City of Portland, Maine – Building or Use Permit Application 389 Congress Street, 04101, Tel: (207) 874-8703, FAX: 874-8716

Location of Construction: 110 Tucker Ave Lot #4 Portland ME		Owner: Martha Bichrest		Phone: 878-0956 842-0162		Permit No: 990909	
Owner Address: SAA		Lessee/Buyer's Name:		Phone:		Business Name:	
Contractor Name: Community Builders		Address: Scar. Me		Phone: Office 883 8194		Permit Issued AUG 20 1999	
Past Use: Vacant New Single Family Home		Proposed Use: New Single Family Home		COST OF WORK: \$98,970.00		PERMIT FEE: \$618.00	
				FIRE DEPT. <input type="checkbox"/> Approved <input type="checkbox"/> Denied		INSPECTION: Use Group 193 Type: 5B BOCA 96	
Proposed Project Description: New Single Family Home w/ attached garage				Signature:		Signature: Hoffe	
				PEDESTRIAN ACTIVITIES DISTRICT (A.D.)			
				Action: <input type="checkbox"/> Approved <input type="checkbox"/> Approved with Conditions <input type="checkbox"/> Denied			
				Signature:		Date:	
Permit Taken By: K.		Date Applied For: Aug. 10, 1999 K.

BUILDING PERMIT REPORT

CITY OF PORTLAND, ME
BOCA 1996 Plan Review Record
One and Two Family Dwelling

SCALE **1" = 20'****LOT 4 # TUCKER WOODS SUBDIVISION****SINGLE FAMILY RESIDENCE
PLOT PLAN**

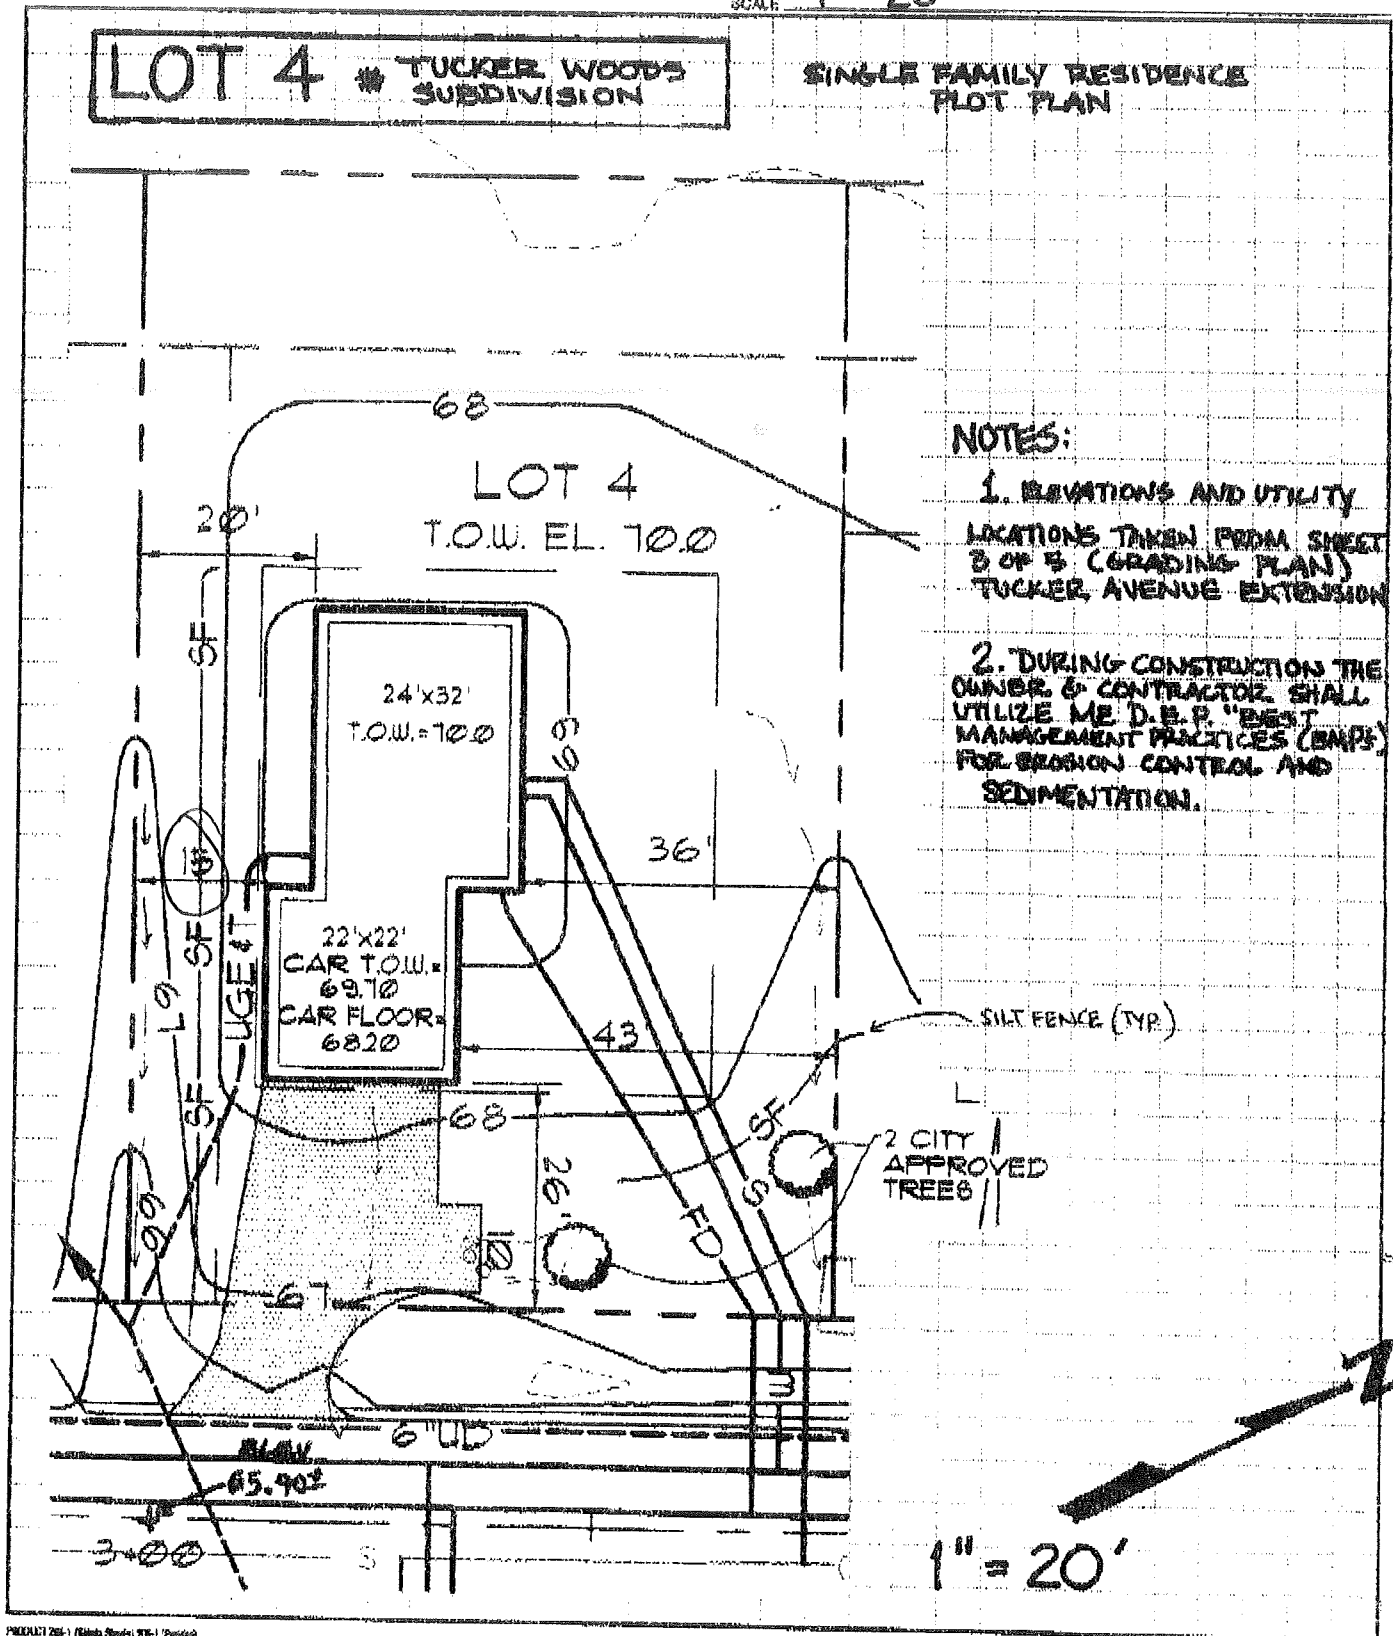
Side Yard - ~~14'~~ 14' req - 15' shown; 36' shown ^{Note!} No rear deck & stairs approved on this - not shown on plot plan - Need an Amendment
